Proposal for Corrigendum 1 to Supplement 9 to the 06 series of amendments to UN Regulation No. 16 (Safety-belts)

Corrigendum 1 to Supplement 9 to the 06 series of amendments to UN Regulation No. 16 (Safety-belts)

"Figure 2

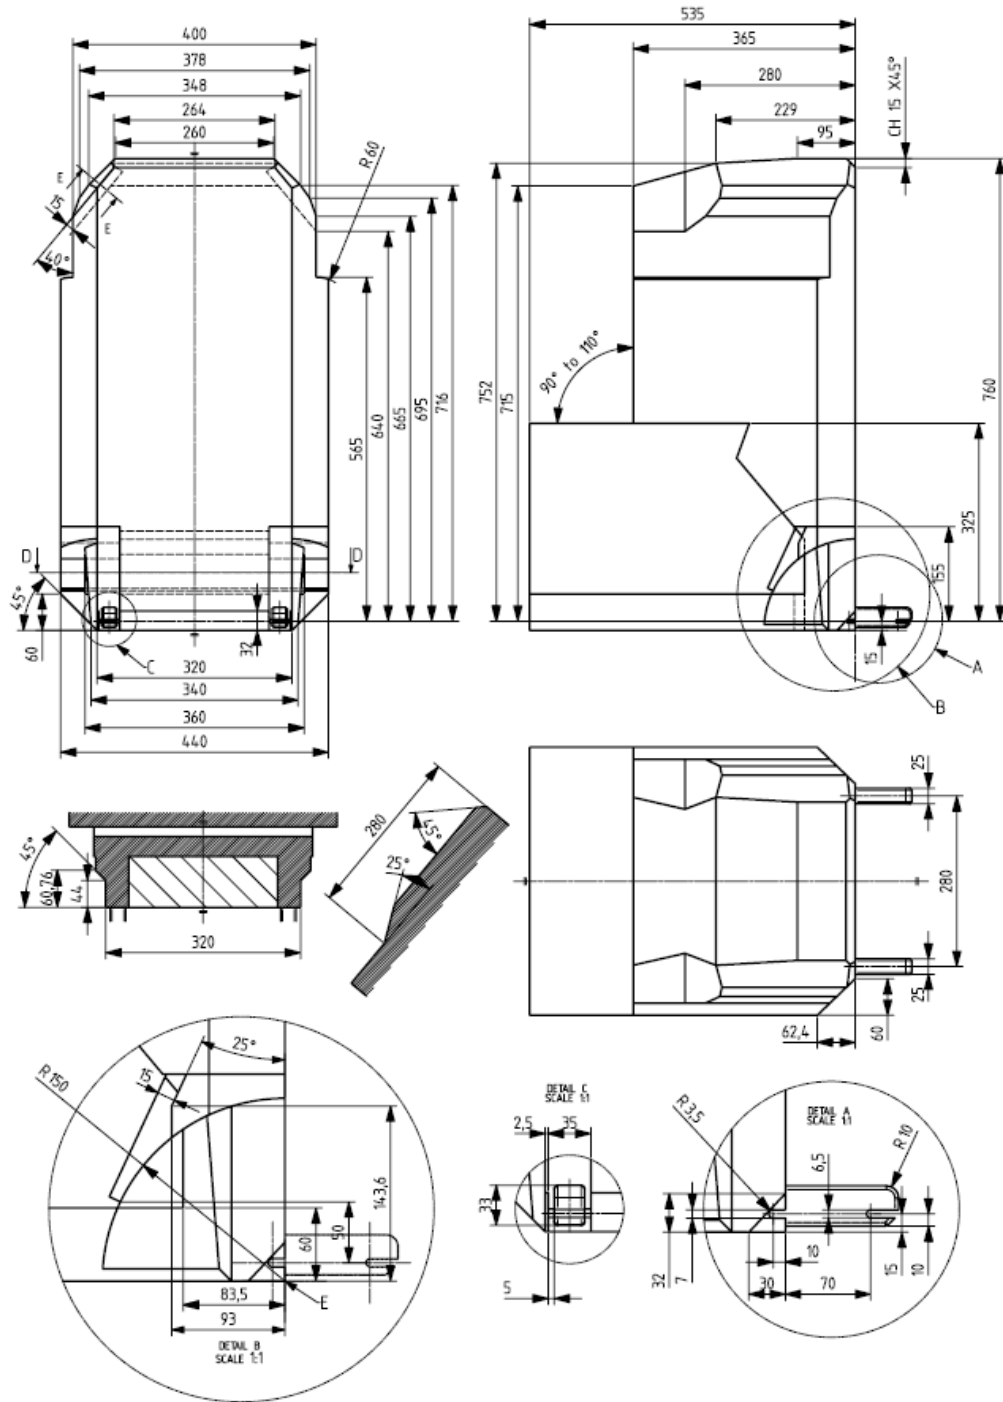
Appendix 5, figure 2 ISO B2, to be replaced as follows:

"Figure 3

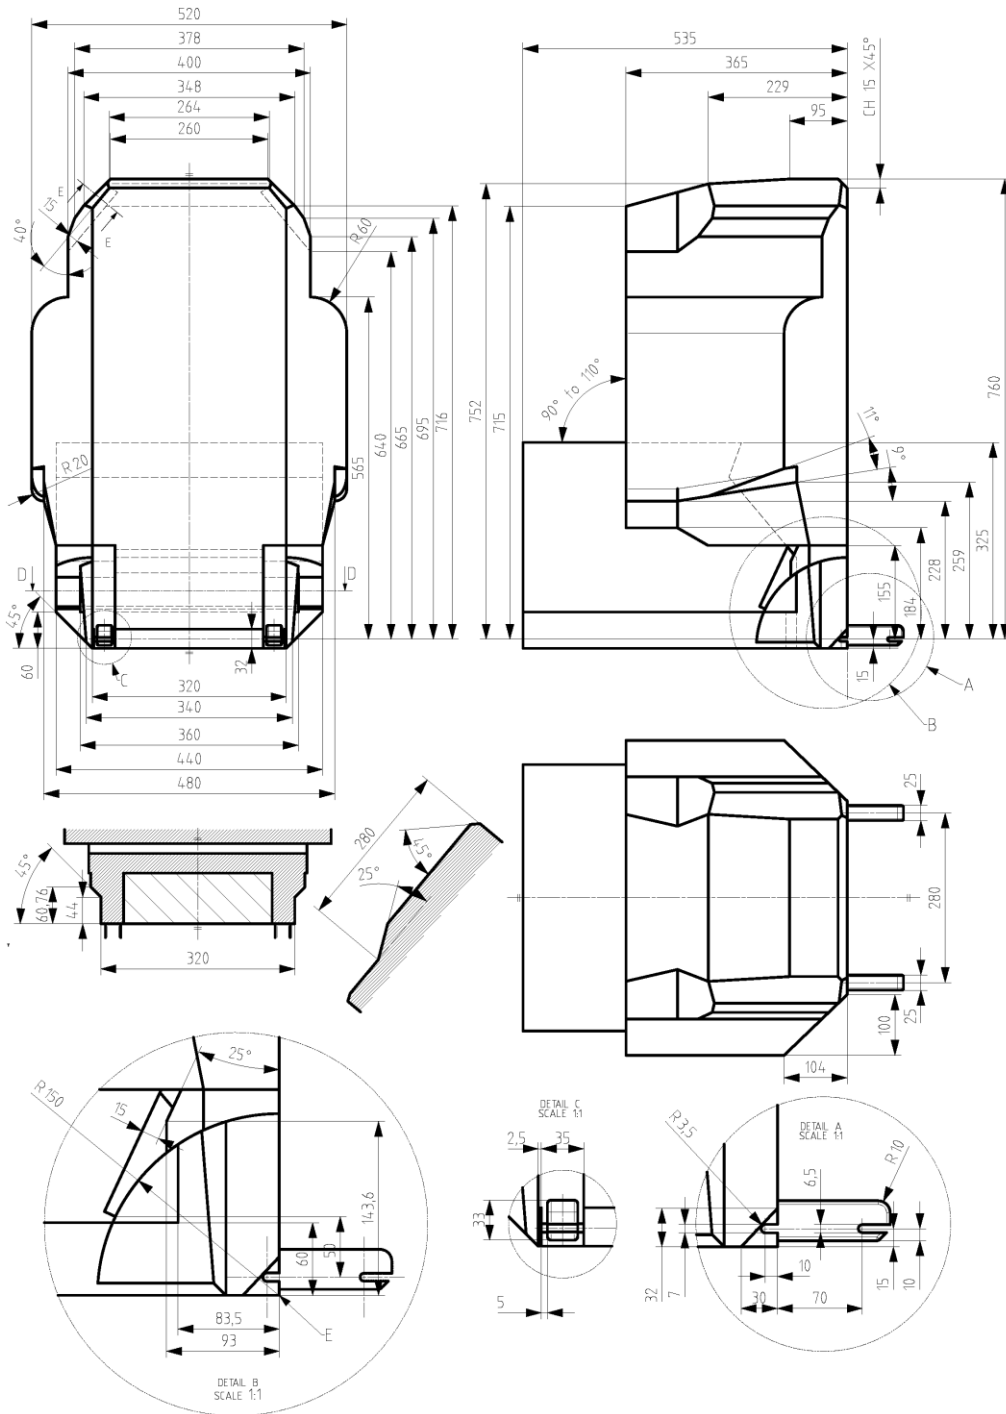
Appendix 5, Figure 3 ISO/B3, to be replaced as follows:
